. APPLICATION NO.	FILING DATE	FIRST NAMED INVENTOR	ATTORNEY DOCKET NO.	CONFIRMATION NO.
10/812,993	03/31/2004	Hideki Kuwajima	43890-672	6416
McDERMOTT	7590 01/05/2007 , WILL & EMERY	EXAMINER		
600 13th Street, N.W.			MAGEE, CHRISTOPHER R	
Washington, DC 20005-3096			ART UNIT	PAPER NUMBER
			. 2627	2
SHORTENED STATUTOR	RY PERIOD OF RESPONSE	MAIL DATE	DELIVERY MODE	
3 MC	ONTHS	01/05/2007	PAPER

Application No.	Applicant(s)	
		10/812,993	KUWAJIMA, HIDEKI	
	Office Action Summary	Examiner	Art Unit	
		Christopher R. Magee	2627	
Period fo	The MAILING DATE of this communication apport	1	correspondence address	
A SH WHIC - Exter after - If NC - Failu Any	ORTENED STATUTORY PERIOD FOR REPLY CHEVER IS LONGER, FROM THE MAILING DANSIONS of time may be available under the provisions of 37 CFR 1.13 SIX (6) MONTHS from the mailing date of this communication. Operiod for reply is specified above, the maximum statutory period vere to reply within the set or extended period for reply will, by statute, reply received by the Office later than three months after the mailing ed patent term adjustment. See 37 CFR 1.704(b).	ATE OF THIS COMMUNICATION 36(a). In no event, however, may a reply be tir will apply

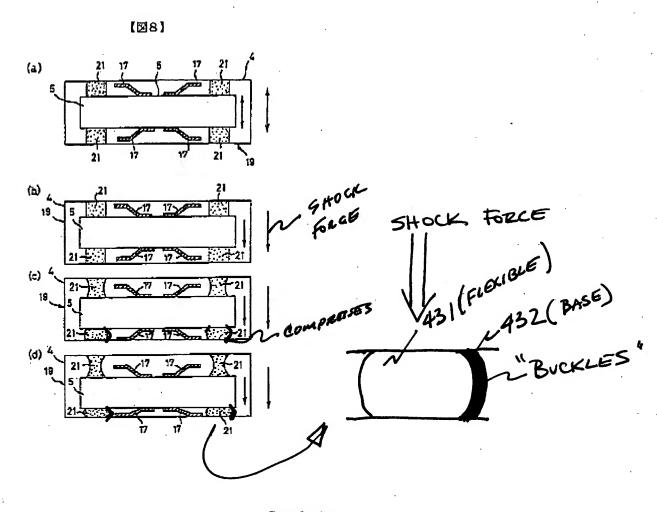
Regarding claims 1, 5, 6, 8, 12, 13 and 20, Yamamura discloses a shock-absorbing member 21 disposed on a main body of electronic equipment (i.e., disk drive) [Fig. 8] and comprising a shock-absorbing flexible part [shown but not numbered].

When subjected to compressive loading, i.e., shock/impact, the shock absorbing member of Yamamura and Ohnishi will absorb a shock when receiving an impact and the shock-absorbing base part will buckle [see annotated Fig. 8].
